To: T10 Technical Committee
From: Amr Wassal, PMC-Sierra (amr_wassal@pmc-sierra.com)
Stephen Finch, STMicroelectronics (steve.finch@st.com)
Date: 20 September 2006
Subject: 06-324r9 SAS-2 Modifications to the SAS Speed Negotiation

Figure 131— SP (phy layer) state machine - SAS speed negotiation states

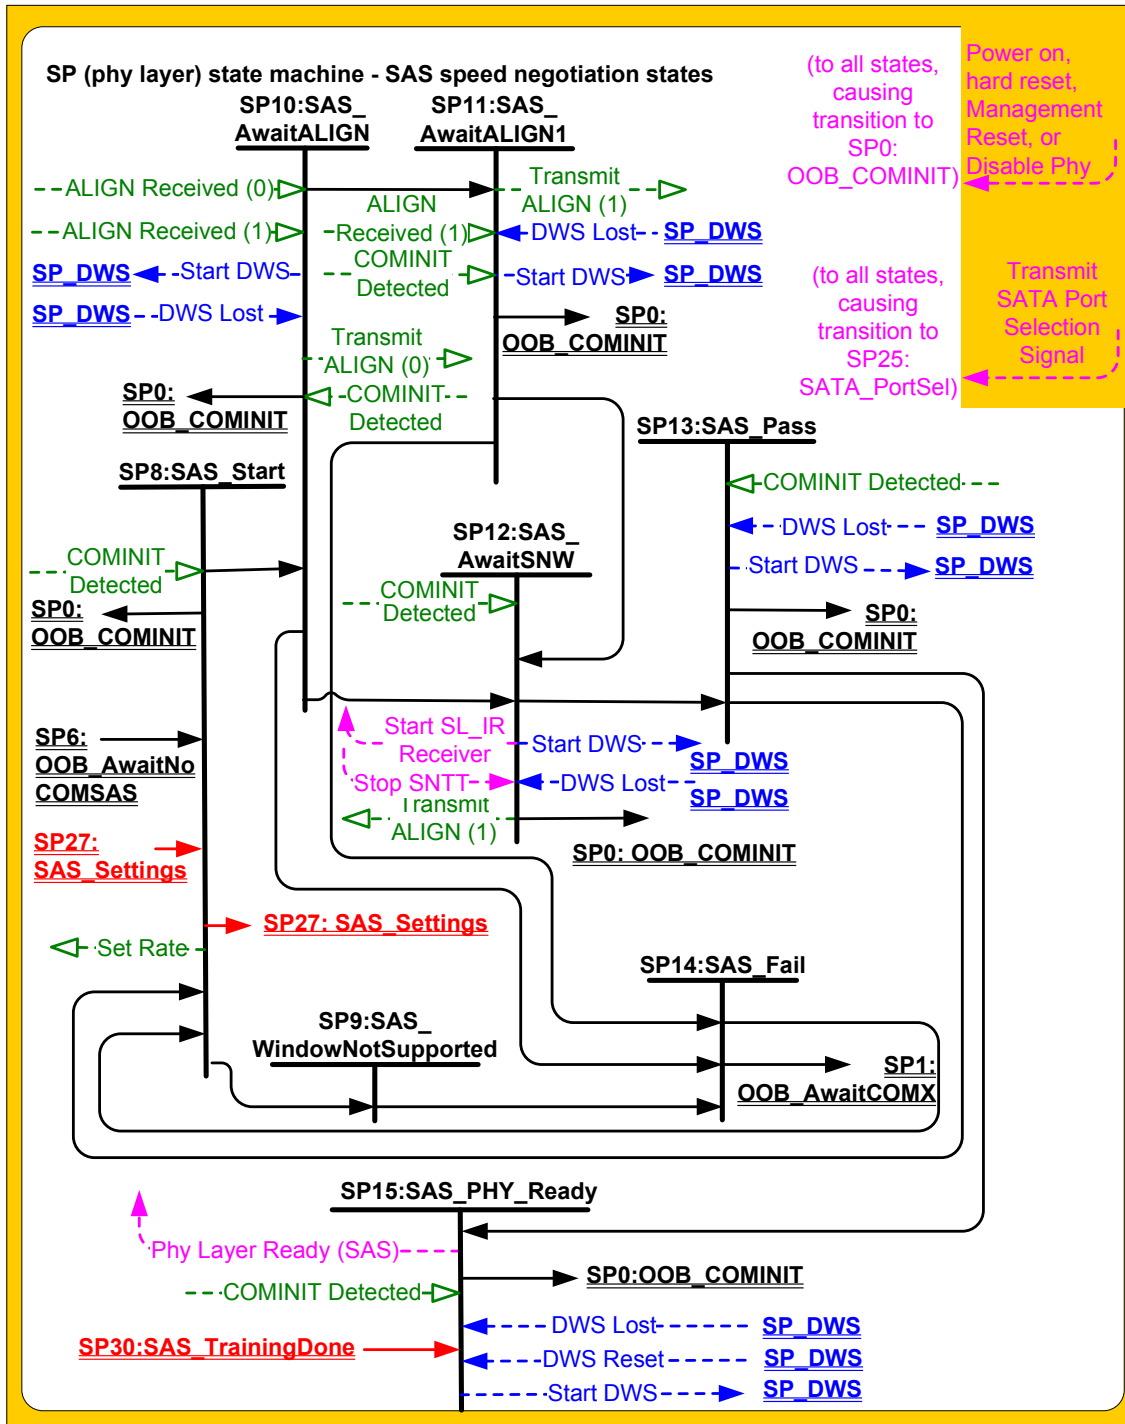
Changes to Figure 132 are in RED and Underlined in the figure. The associated transition arrows are also added in RED.

Figure 132 — SP (phy layer) state machine - SAS speed negotiation states related to SNW-3 and Final-SNW

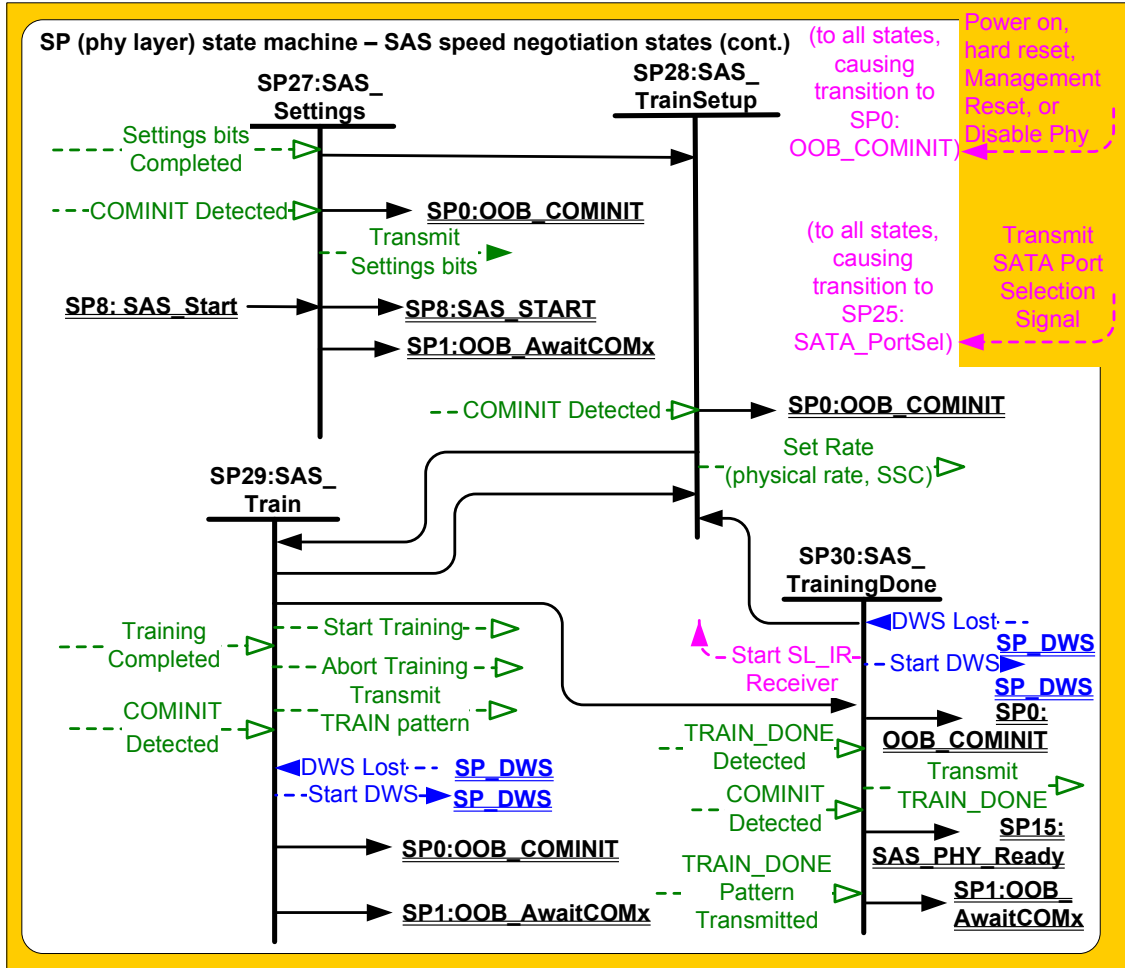
Figure 132 is a completely new figure.
